Access Compliance Report

Public Rights-of-Way

(Curb Ramps)

| Intersection ID: 18726 | Main Street: TYVOLA_RD | Cross Street: OLD_PINEVILLE_RD | Location: NW |

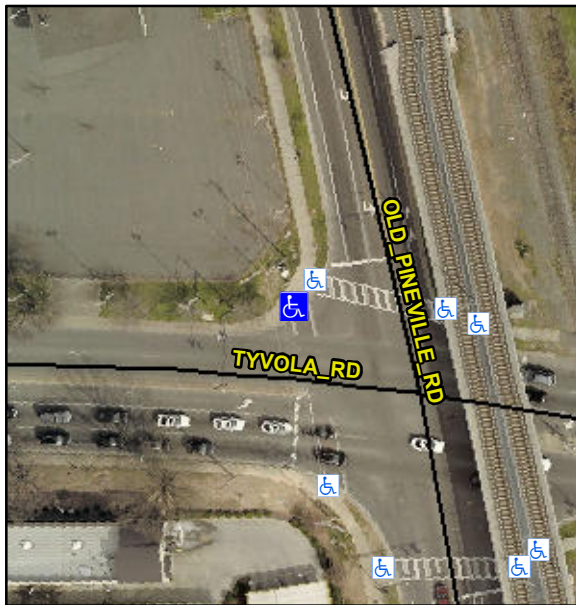
Not Found, R304.5.1, R304.2.2, R304.5.3

| Compliance | Description | Data | Compliance | Description | Data |
|------------|-----------------------|-------|------------|-----------------------------|------|
| N/A | Ramp Length (in) | 118.0 | No | Ramp Slope (%) | 8.6 |
| No | Ramp Width (in) | 47.0 | No | Ramp XSlope (%) | 4.1 |

Remove & Replace Entire Ramp.
